Item 10. Coastal Submarine Discharge

Figure 10.1 Example Figure Illustrating Variable Discharge to Pearl Harbor

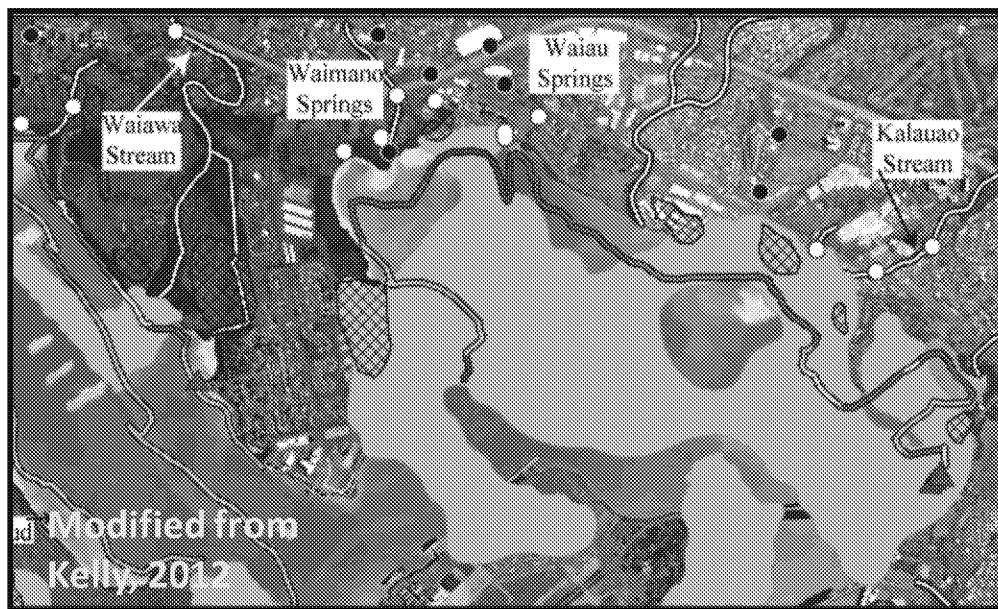
Although uncertain in extent and character, it is important to represent the downgradient outflow conditions as accurately as possible, using as one basis the CSM regarding the distribution and properties of these features, and also other sources of information (Inset Figure 10.1). The solution likely lies in two parts: First, re-interpretation of the available data, and expanded use of sensitivity analysis and model calibration to help identify probable geometries and properties. Second, based on the anticipated results of sensitivity analyses conducted with this updated representation of these features, consideration should be given to methods of data collection to better constrain the likely presence, extent and properties of these features.
